**Technical Publication
Transfer Test with
McDonnell Aircraft Company:
MIL-M-28001 (SGML) and
MIL-D-28000 Class I (IGES)**

June 25, 1990

Prepared by
Syscon Corporation
and Lawrence Livermore
National Laboratory

Exhibit 1: MCAIR's Illustration 1 as originally drawn and plotted

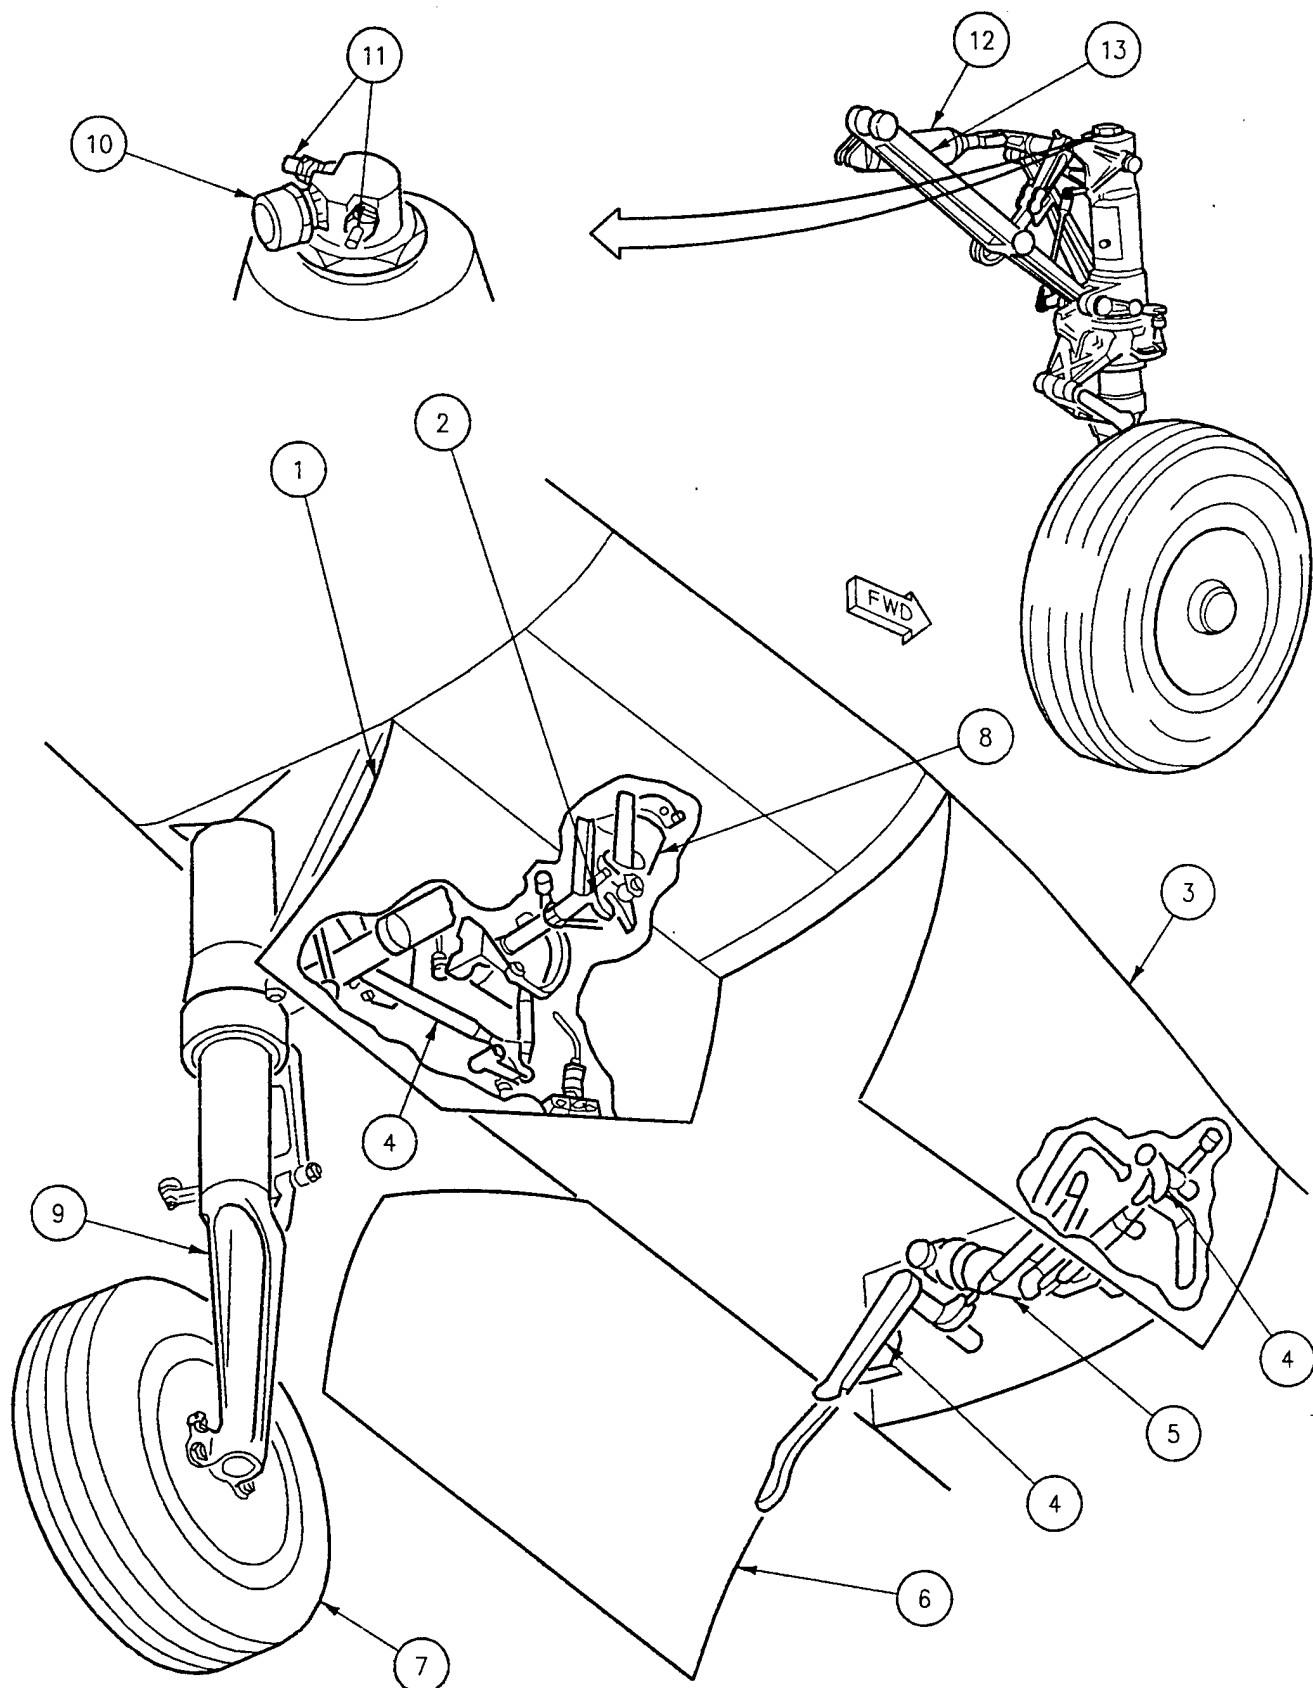
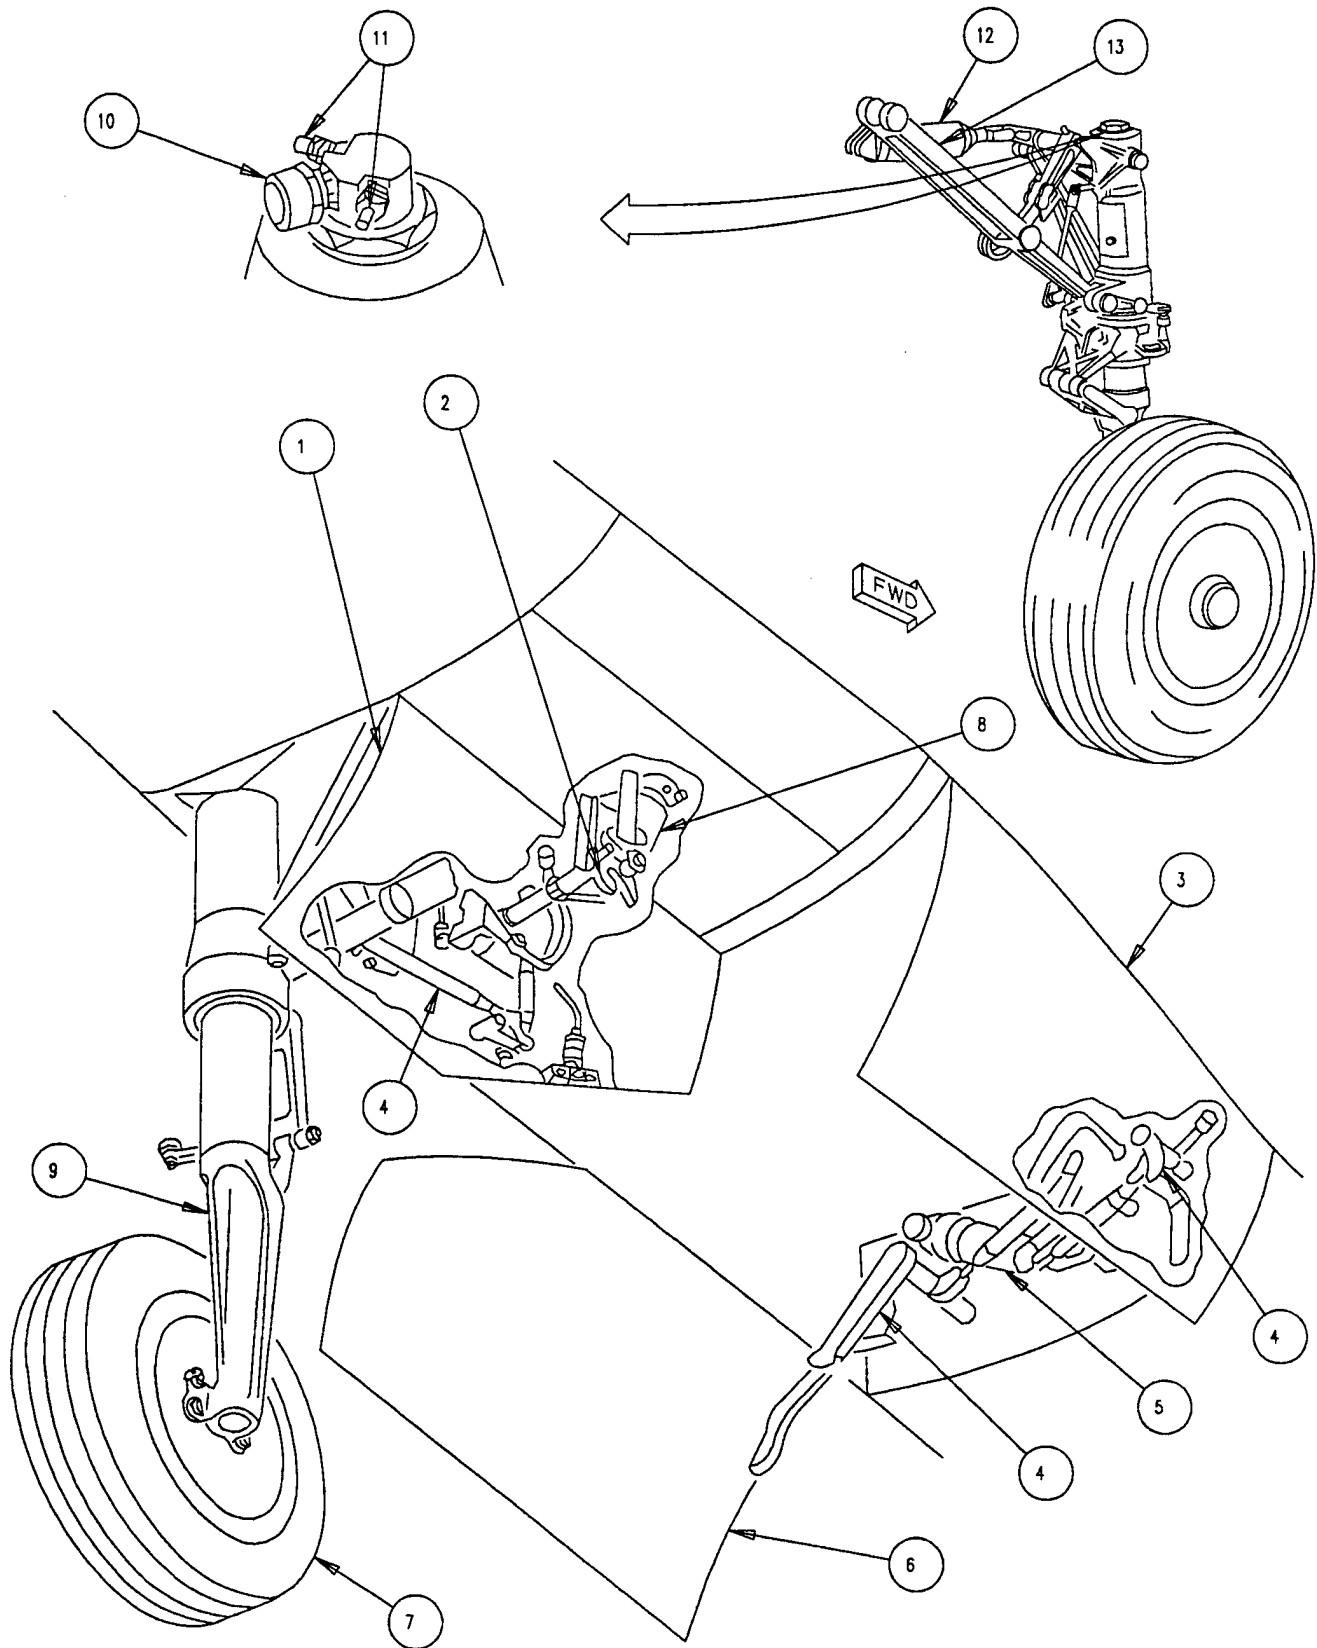
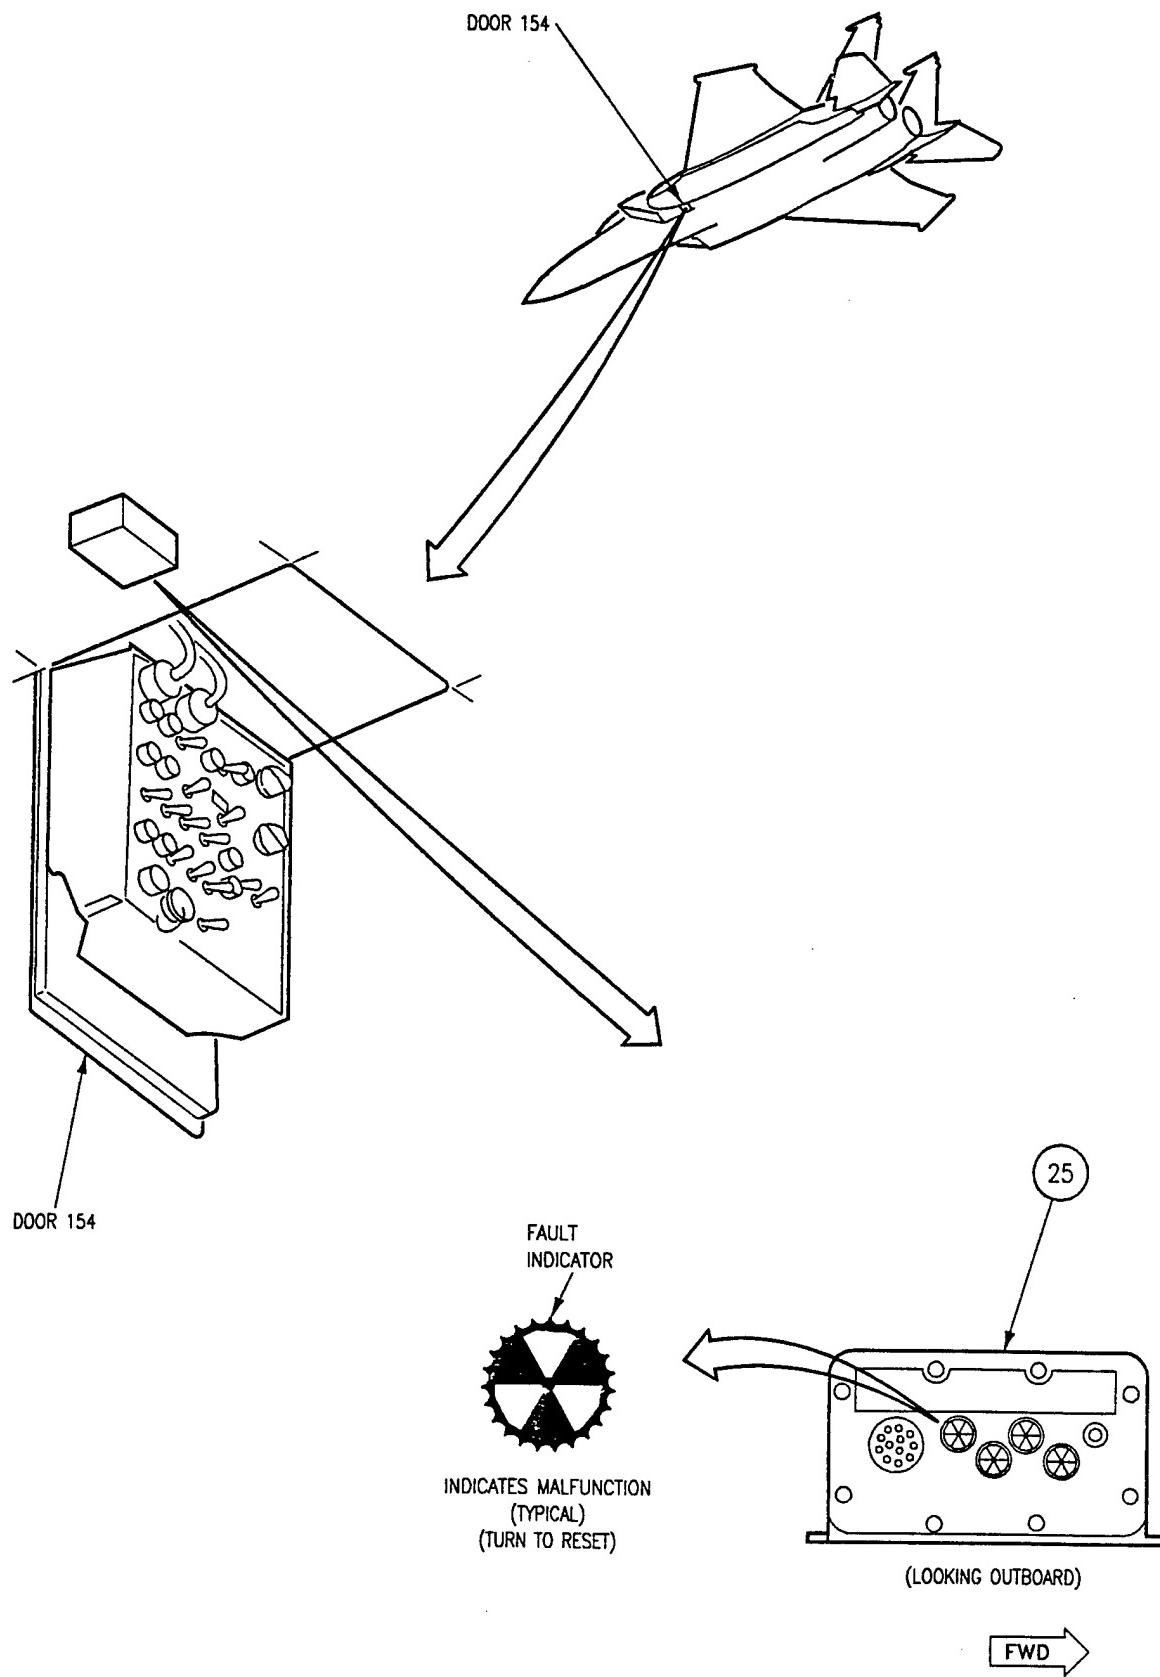
Exhibit 2: MCAIR's Illustration 1 after IGES translation.
Note the smaller text and misshaped arrowheads.

Exhibit 3: MCAIR's Illustration 31 as originally drawn and plotted.

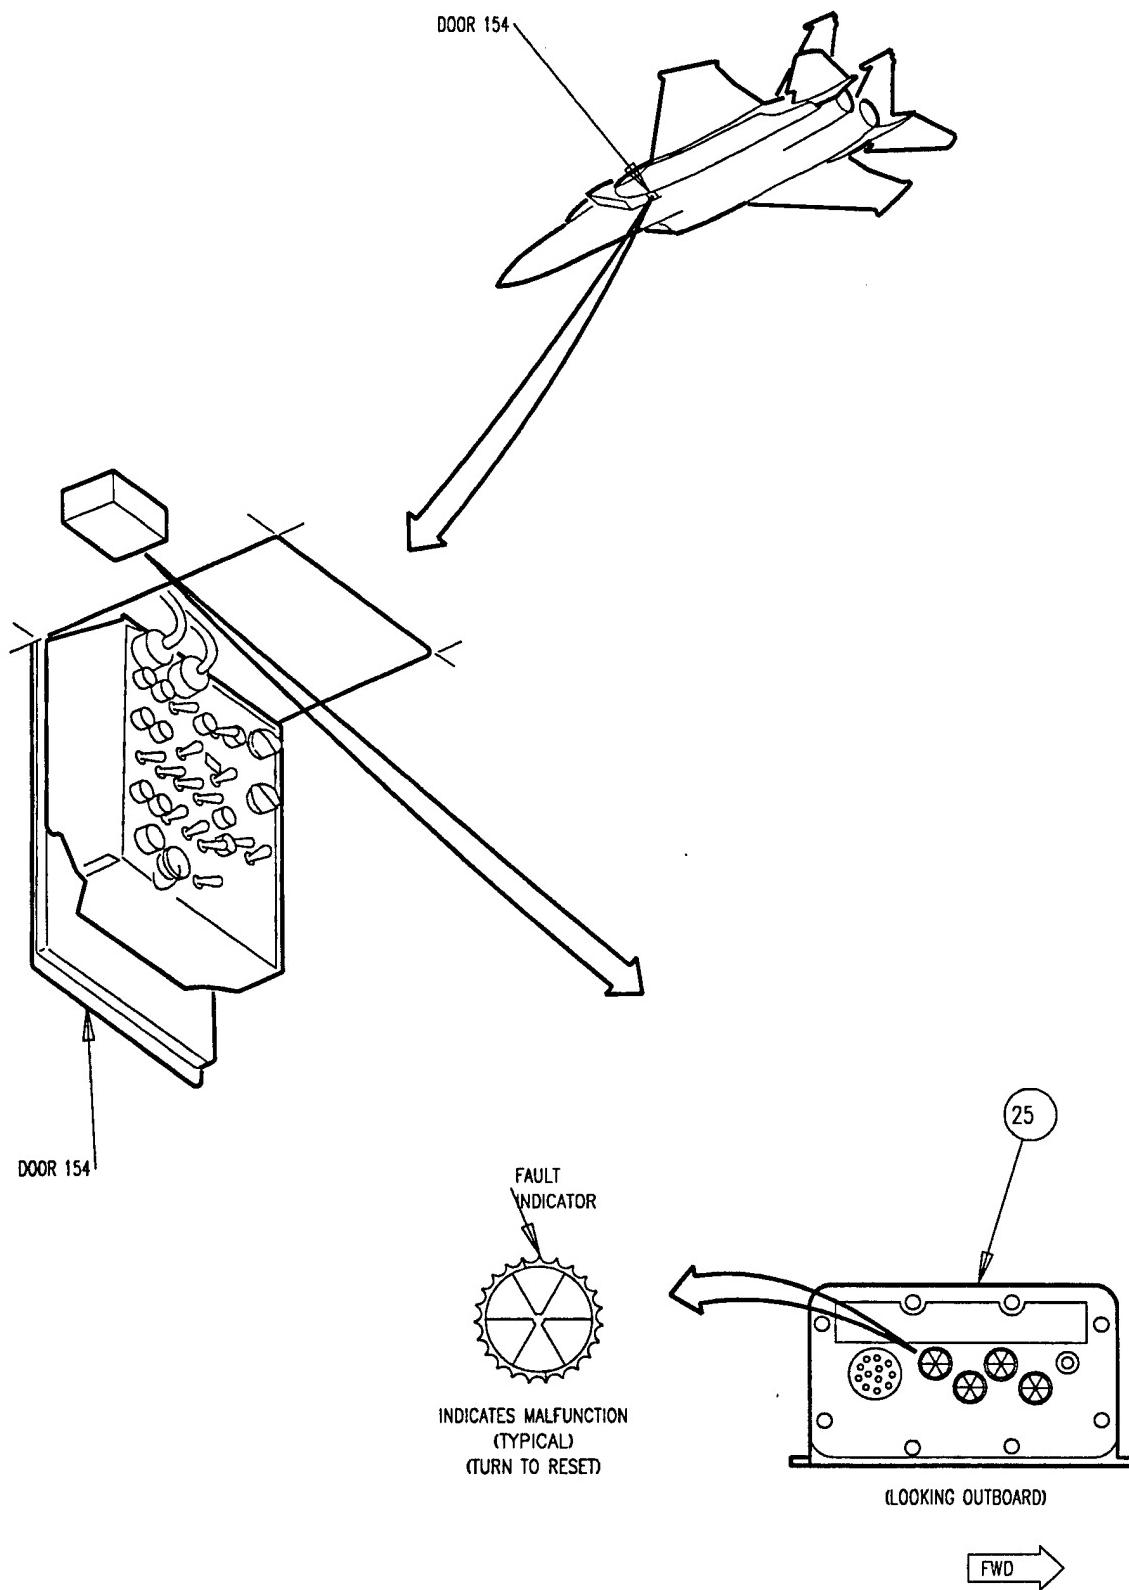
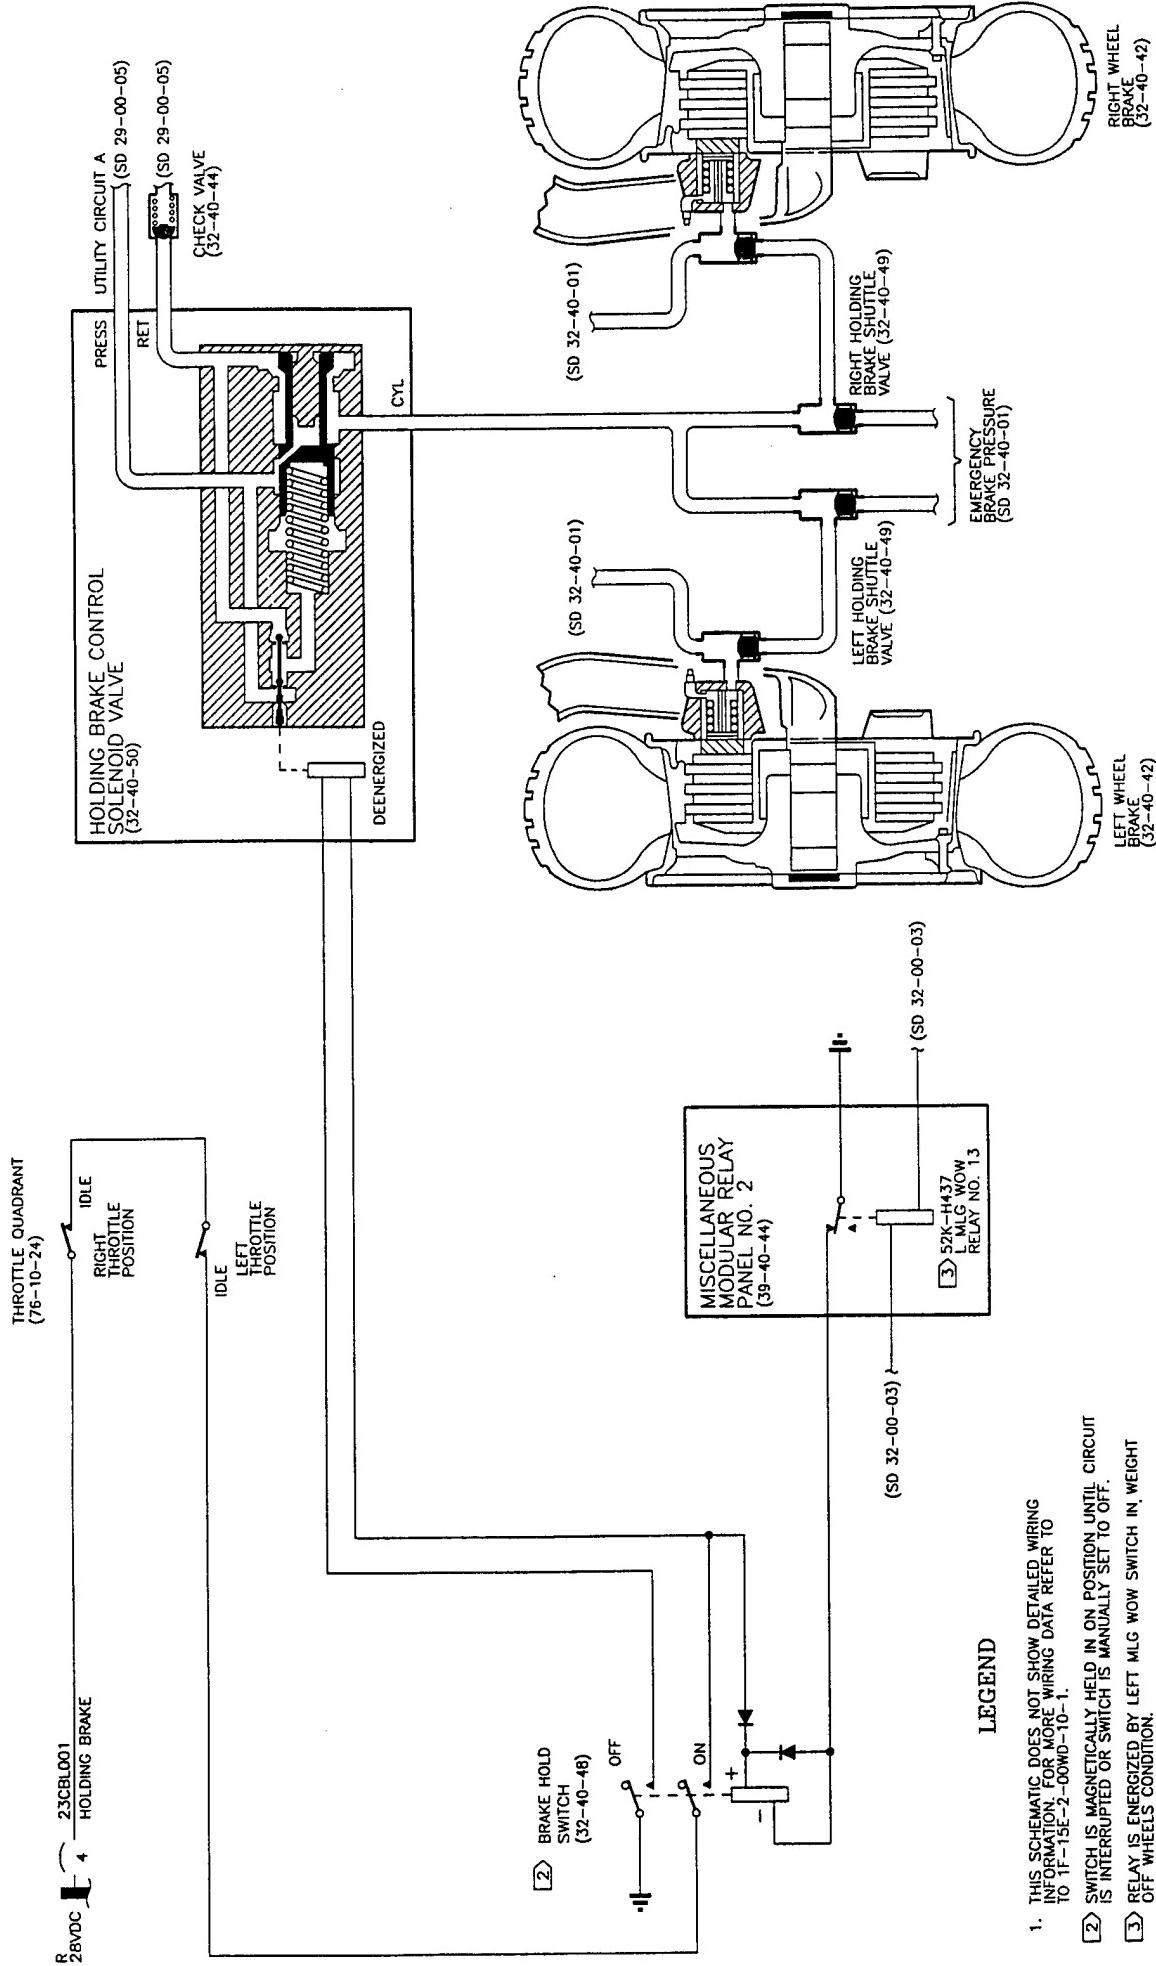
Exhibit 4: MCAIR's Illustration 31 after IGES translation.
Note the missing solid fill and misplaced arrow.
